STATE OF NORTH CAROLINA
DEPARTMENT OF TRANSPORTATION

Subject: Subdivision Final Plan Review – Phase III – Cedar Mountain Subdivision off of Jones Ferry Road (SR 1540)

The N. C. Department of Transportation, Division of Highways has reviewed the construction plans signed and sealed by Samir Bahho P.E. on March 16, 2015 as submitted to this office and approval is granted subject to the following stipulations and recommendations:

NEW LOCAL RESIDENTIAL ROAD OR COLLECTOR ROAD AND EXISTING STATE MAINTAINED ROAD WITHOUT CURB AND GUTTER

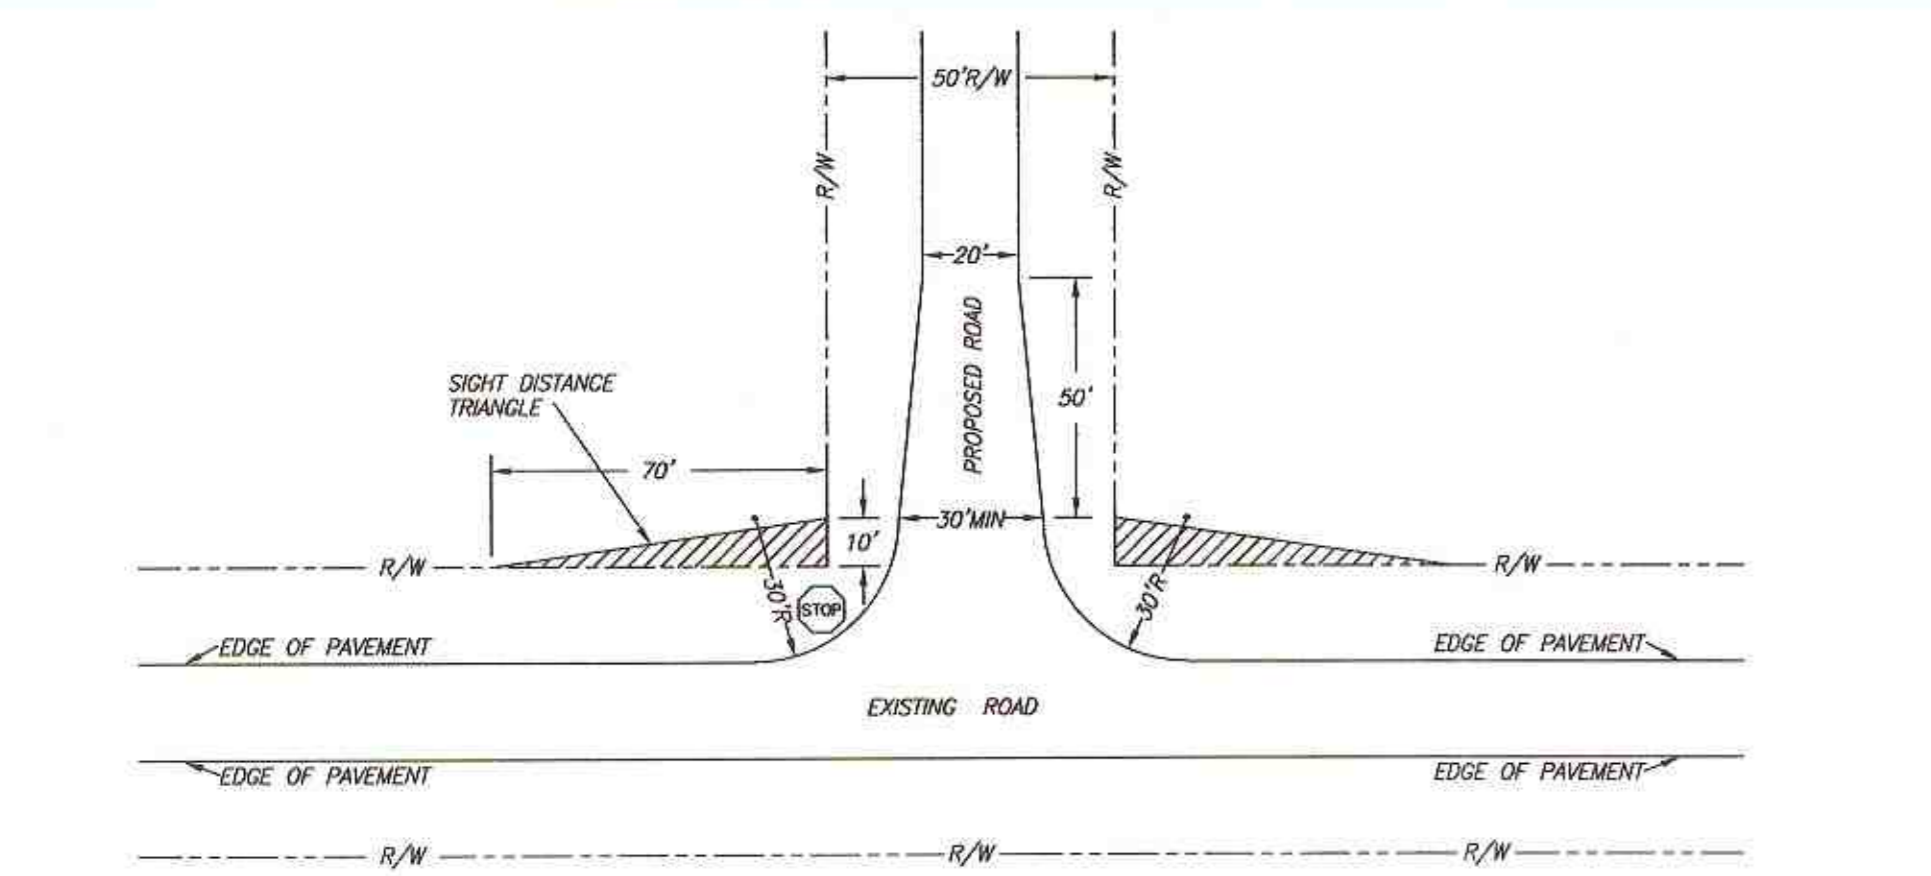
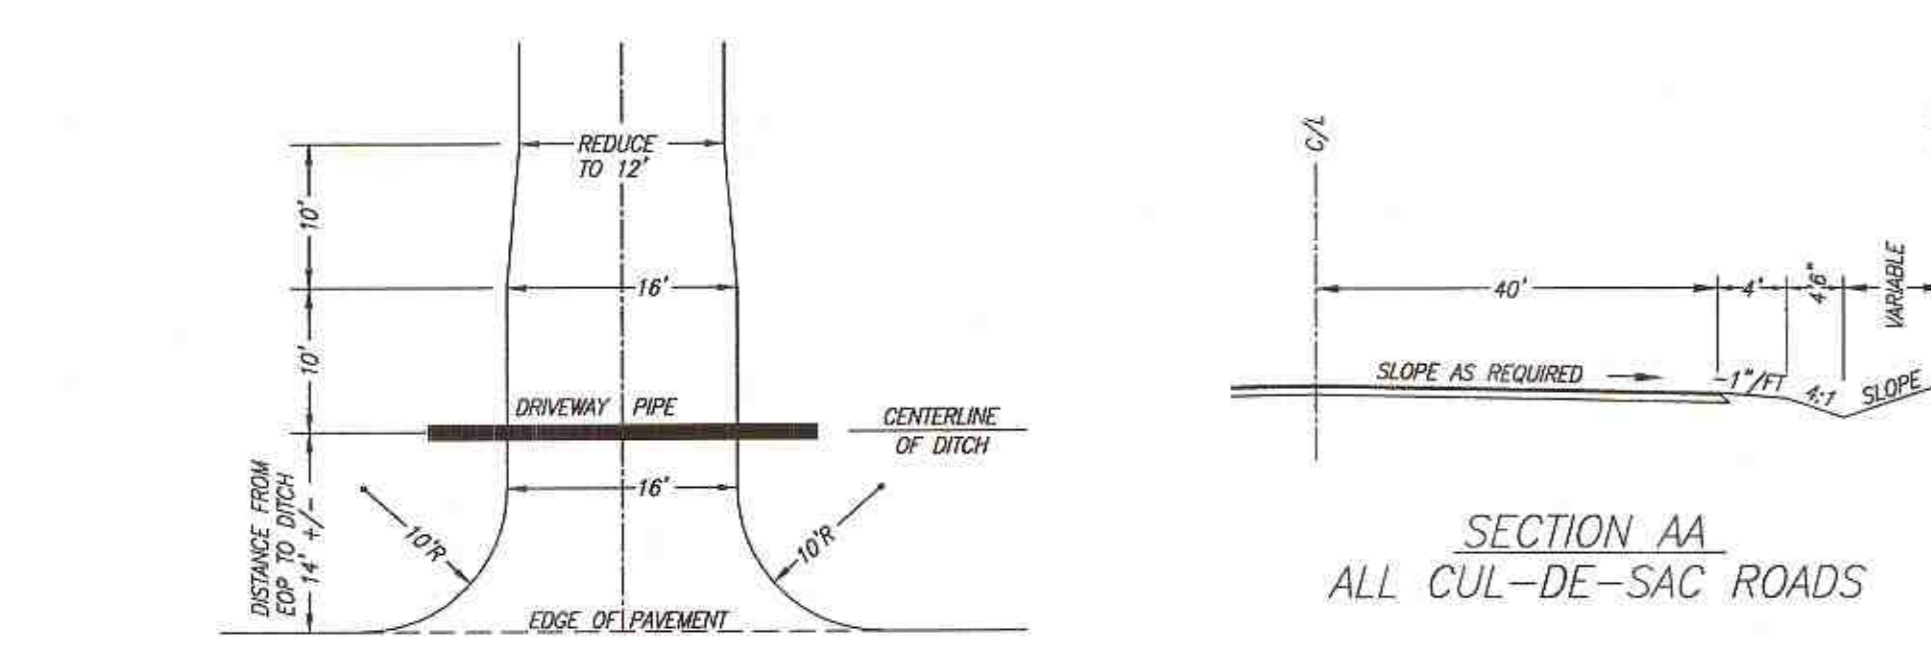
6. The typicals as shown in the plans, are approved.
7. The Division of Highways will only allow mailboxes, with non-rigid type post, such as 4" x 4" wooden or small diameter metal type on new additions. Brick columns or mailboxes on rigid stands such as block, stone or any other type deemed to be a traffic hazard will not be allowed within the right of way. This policy applies to all roads being considered for addition to the State Maintained System.
